SAKURA
Filtration Product

Design Change For Water Coolant Filter WC-5711, WC-6901 & WC-7901

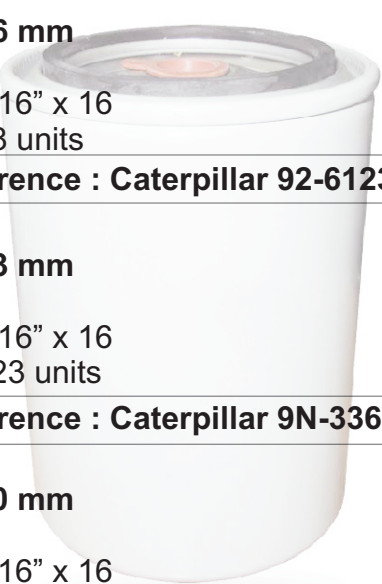
We have changed the design of Water Filter WC-5711, WC-6901 & WC-7901, the main changed is the HEIGHT of the filter.

SPECIFICATION	
OLD	NEW
WC-5711 Height : 136 mm OD : 93 mm Thread : 11/16" x 16 Coolants = 8 units 	WC-5711 Height : 100 mm OD : 93 mm Thread : 11/16" x 16 Coolants = 8 units 
Cross Reference : Caterpillar 92-6123, Cummins 3315115, Fleetguard WF2073	
WC-6901 Height : 223 mm OD : 93 mm Thread : 11/16" x 16 Coolants = 23 units	WC-6901 Height : 189 mm OD : 93 mm Thread : 11/16" x 16 Coolants = 23 units
Cross Reference : Caterpillar 9N-3367, Komatsu 600-411-1040, Fleetguard WF2055	
WC-7901 Height : 140 mm OD : 93 mm Thread : 11/16" x 16 Coolants = 8 units	WC-7901 Height : 100 mm OD : 93 mm Thread : 11/16" x 16 Coolants = 8 units
Cross Reference : SAAB-SCANIA 378396, Fleetguard WF2081

By this information, **WC-5711, WC-6901 & WC-7901** with old dimension is not available.
